SUMMARY OF TOPICS

The following changes in requirements are being proposed:

1. For Preliminary Review Only: Revision of the Scope - Greater than 600 V Applications

Figure 1.1
Connector type designations

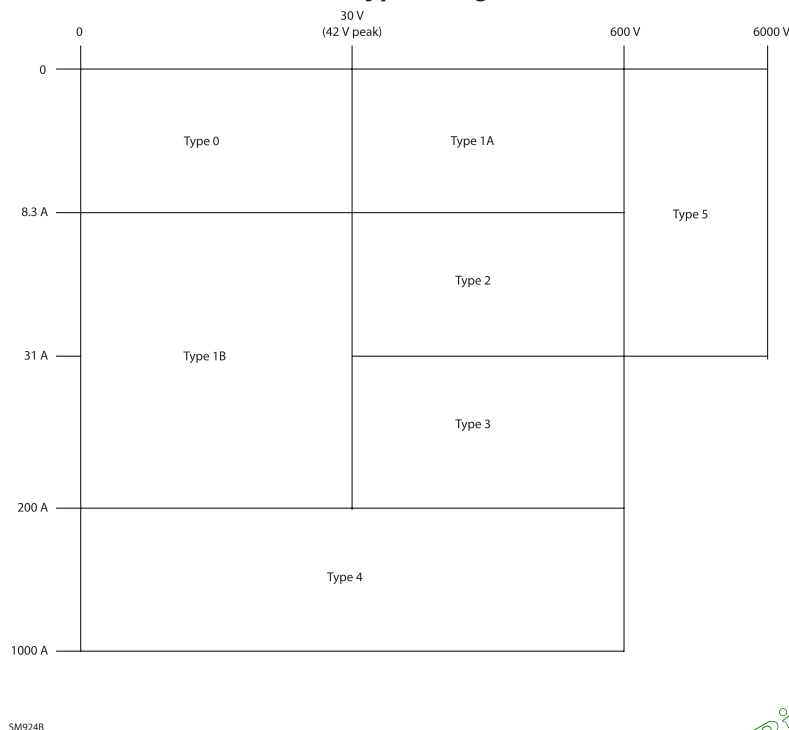
Connectors have been evaluated for greater than 600 V applications based on applying the end product requirements such as Spacings and Dielectric Withstand tests. Such connectors are used in high voltage applications in monitors, arc-lamp fixtures, etc., which often utilize connectors in high voltage circuits up to 6 kV. These high voltage applications are often at startup or of a short duration.

Connectors evaluated for these specific end product high voltage applications have not been limited to the 600V maximum rating in 1.2. The spacing requirements and dielectric withstand test potential are based upon the requirements of the end product.

UL proposes a new Type 5 be established for connectors rated less than 31 A and from 601 V up to and including 6000 v ac or dc, or both.

- d) Type 2 rated from 8.3 A to less than 31 A and from 30 V up to and including 600 V ac or dc or both;
- e) Type 3 rated from 31 A up to and including 200 A and from 30 V up to and including 600 V ac or dc, or both.
- f) Type 4 rated from greater than 200 A up to and including 1000 A, and up to and including 600 V ac or dc.
- g) Type 5 rated less than 31 A and from 601 V up to and including 6000 V ac or dc, or both.

Type designations used in this Standard only serve as a guide to determine appropriate requirements, and do not represent an assigned rating.

A device not without an assigned a current rating is considered either to be either a Type 0 or Type 1A depending upon the assigned voltage rating.
